Docket Nos. 50-280
and 50-281 ✓

bcc: H. Mueller, GMR/H
J. R. Buchanan, ORNL
T. W. Laughlin, DTIE
F. W. Karas, SECY
Change No. 4
License No. DPR-32

As a part of the operating license review conducted for Surry Power Station Units 1 and 2, a single set of Technical Specifications was developed and intended to be used as the Regulatory requirements for the licensed operation of both Unit 1 and Unit 2. These Technical Specifications were subsequently incorporated as Appendix A to Operating License No. DPR-32 for Surry Unit 1 issued on May 25, 1972 and are currently in effect for Unit 1.

The specific items considered herein are:

TS Figure 3.1-1
1-17-73

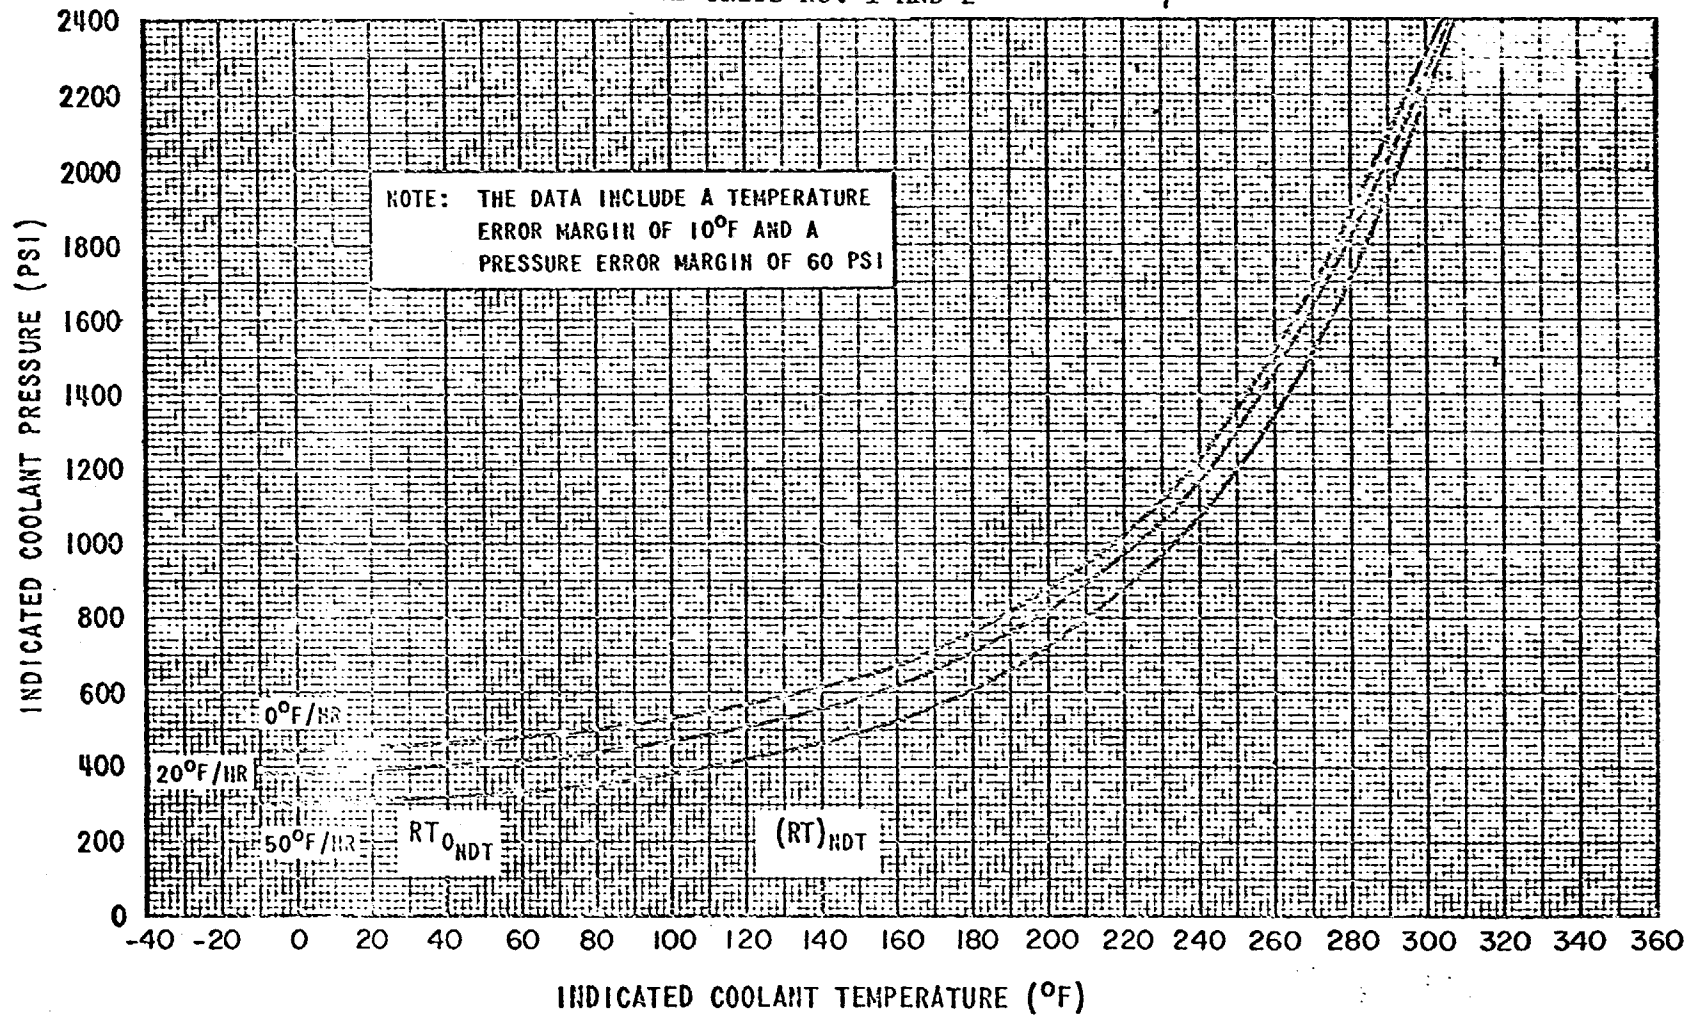
1. Change Technical Specification 3.1.B.1 page TS 3.1-6 (first paragraph) to read, "Unit 1 and Unit 2 reactor coolant temperature and pressure and the system heatup and cool-down (with the exception of the pressurizer) shall be limited in accordance with TS Figure 3.1-1".
2. Change Technical Specification Figure 3.1-1 entitled "Upper Pressurization Limits for Heatup and Cooldown - Surry Unit One" to read "Upper Pressurization Limits for Heatup and Cooldown - Surry Units No. 1 and 2".
3. Change Technical Specification 4.1 by redesignating Table 4.1-3, page TS 4.1-11, entitled "Minimum Frequencies for Flushing Sensitized Pipe" to Table 4.1-3A - Unit No. 1.

The 0°F/hr. curve of Figure 3.1-1 may be used for heatup rates of up to 60°F/hr. below an indicated temperature of 304°F and 100°F/hr. above 304°F .

Allowable combinations of pressure and temperature for a specific cooldown rate are below and to the right of the limit lines for that rate as shown in TS Figure 3.1-1. This rate shall not exceed 50°F/hr. for temperatures at or below an indicated temperature of 308°F . For temperatures above an indicated temperature of 308°F , the rate shall not exceed 100°F/hr. The limit lines for rates between those shown in TS Figure 3.1-1 may be obtained by interpolation.

Figure 3.1-1 Upper pressurization limit for heatup is depicted by "0°F/Hour" curve. Upper pressurization limits for cooldown are dependent as depicted, on the cooldown rates. This figure is applicable through an nvt of 1.1×10^{18} neutrons per cm^2 ($E > 1$ Mev)
